BEACON HILL JSP15-08 with Rezoning 18.710

Public hearing at the request of The Ivanhoe Companies for Planning Commission's recommendation to the City Council for rezoning of property in Section 12, located on the northeast corner of Twelve Mile Road and Meadowbrook Road from RA (Residential Acreage) to R-4 (One-Family Residential) and B-3 (General Business), with a Planned Rezoning Overlay (PRO). The subject property is approximately 21.13 acres. The applicant is proposing a 42-unit single-family residential development with frontage on and access to Meadowbrook Road, up to 22,000 square feet of commercial space with frontage and two access drives on Twelve Mile Road, and an open space/park area at the corner of the intersection.

PLANNING REVIEW

**SUBJECT: Review of Beacon Hill Park
JSP15-0008 Rezoning 18.710 with a PRO Concept Plan**

sheet title:
 site plan

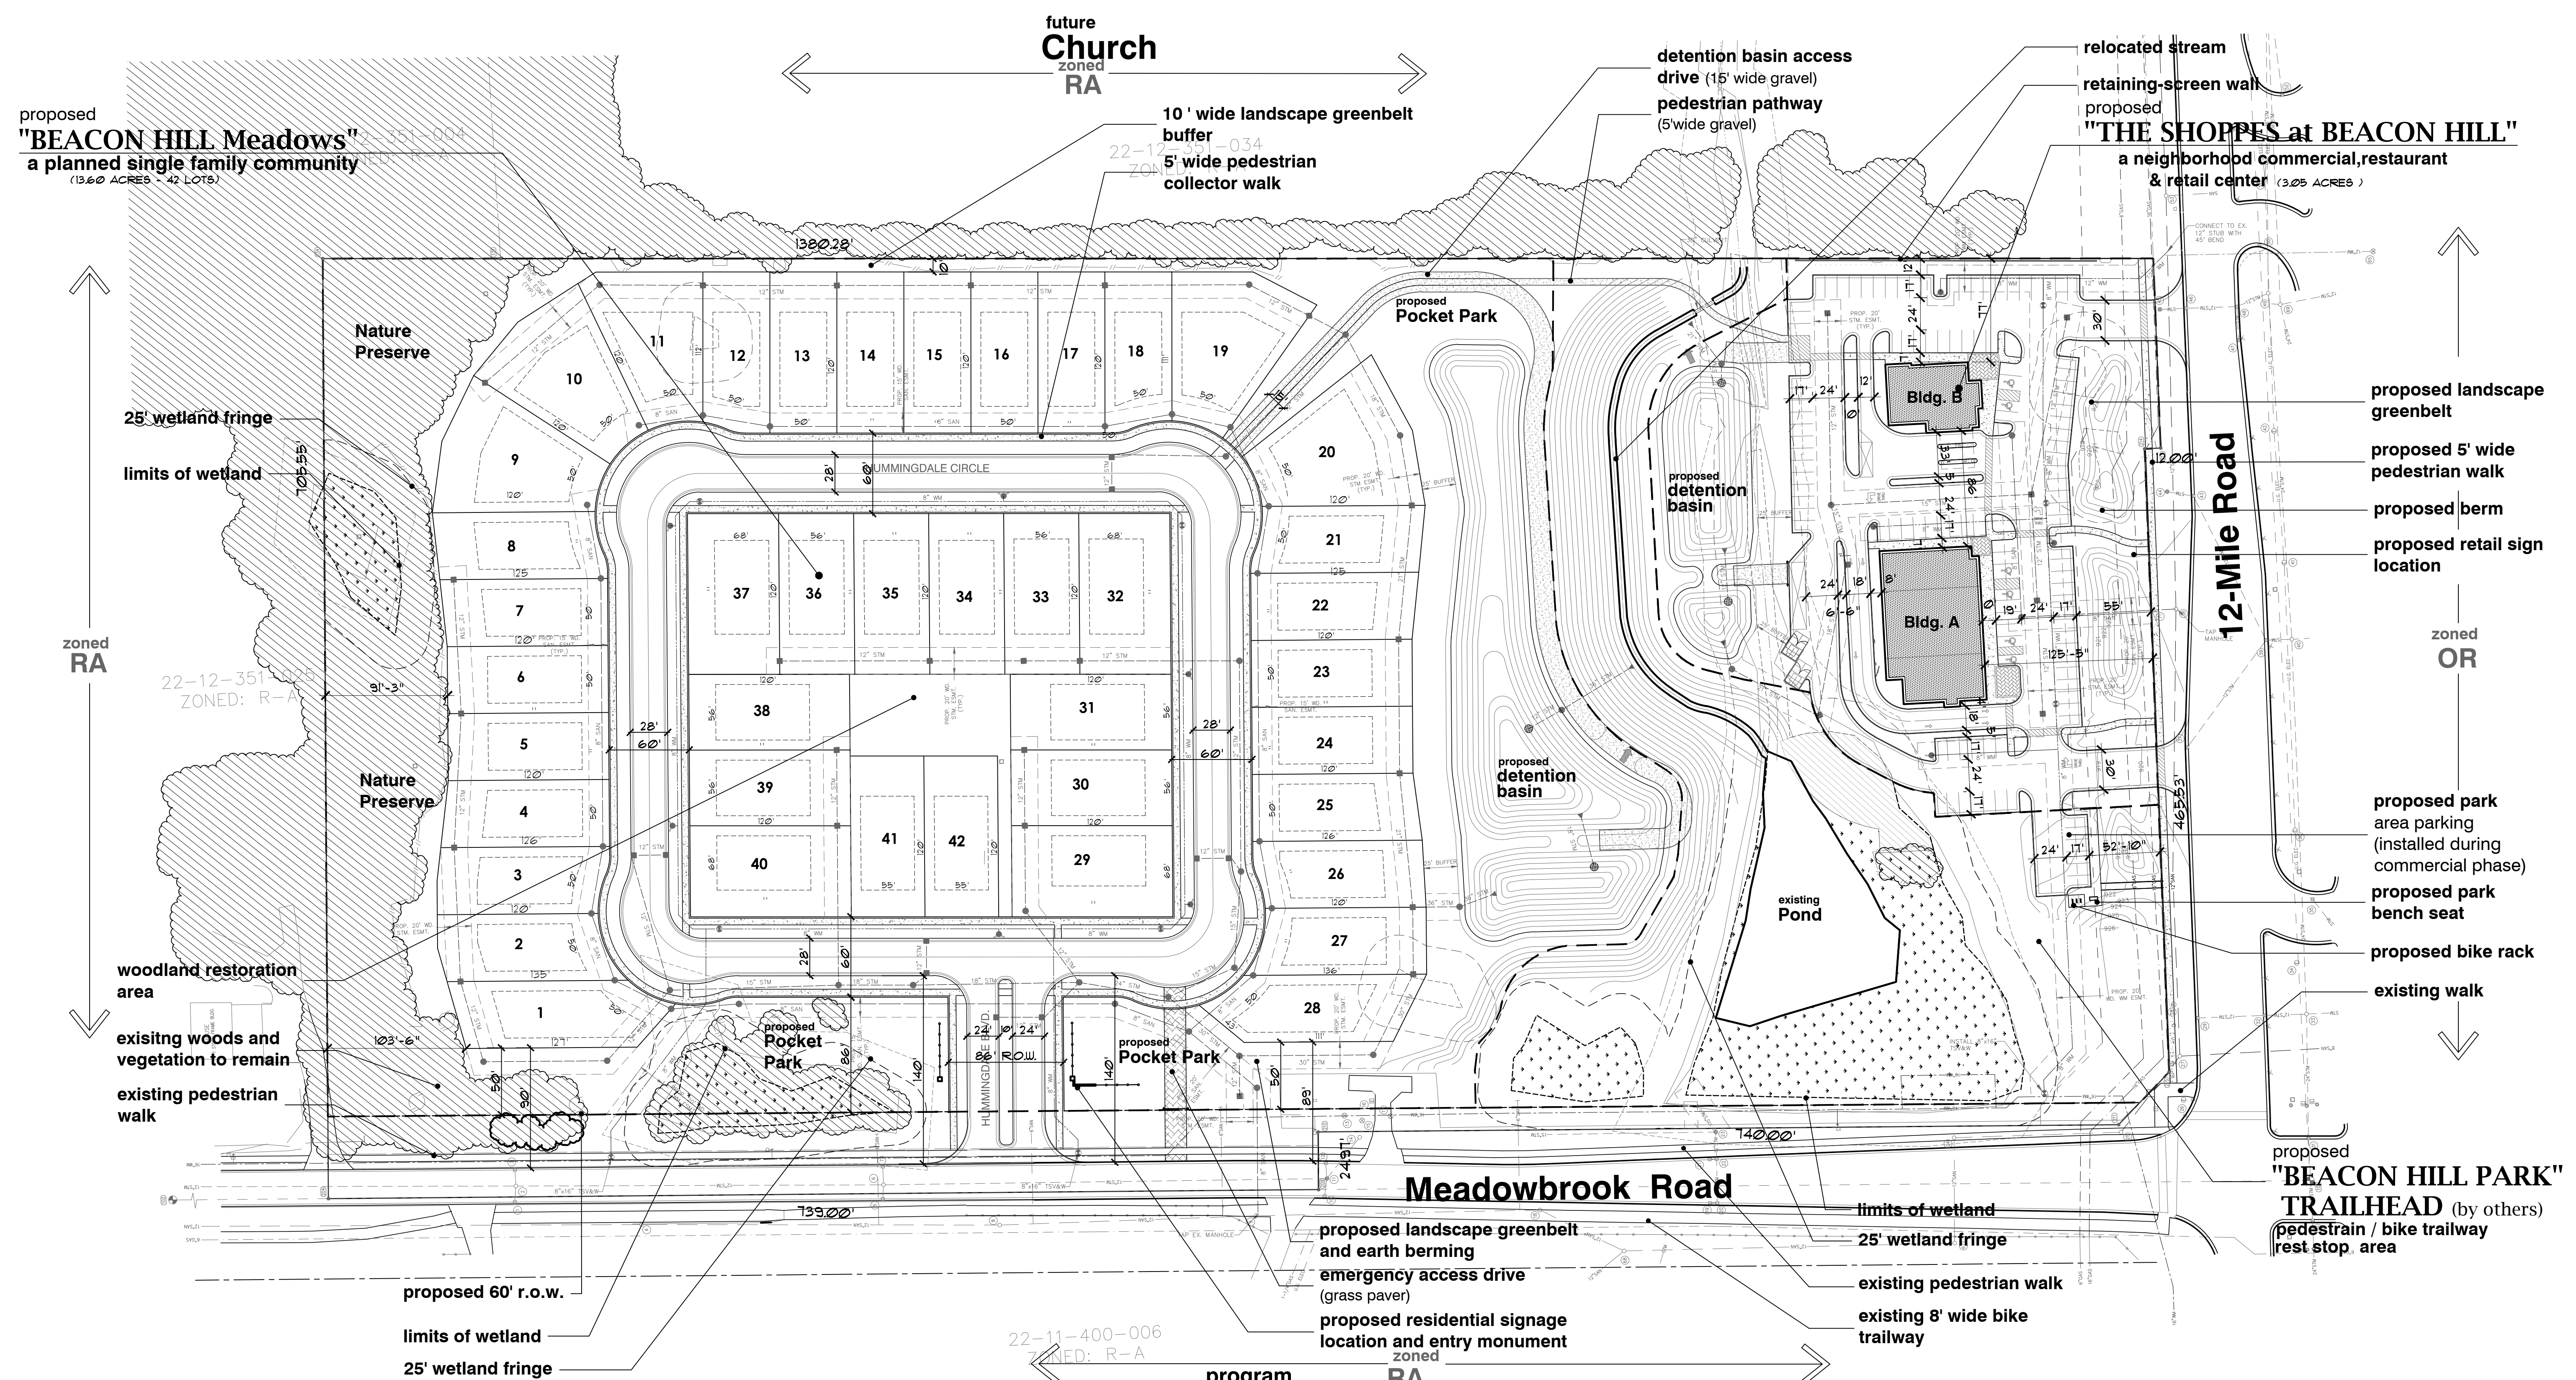
The letter and site plan indicate that this is a preliminary site plan. However, we note that this is a conceptual PRO plan.

This is an amended version of an earlier concept plan. Generally, this version of the proposal reduced overall residential density and increases the amount of land dedicated as open space, including an increase in the amount of land donated for a park.
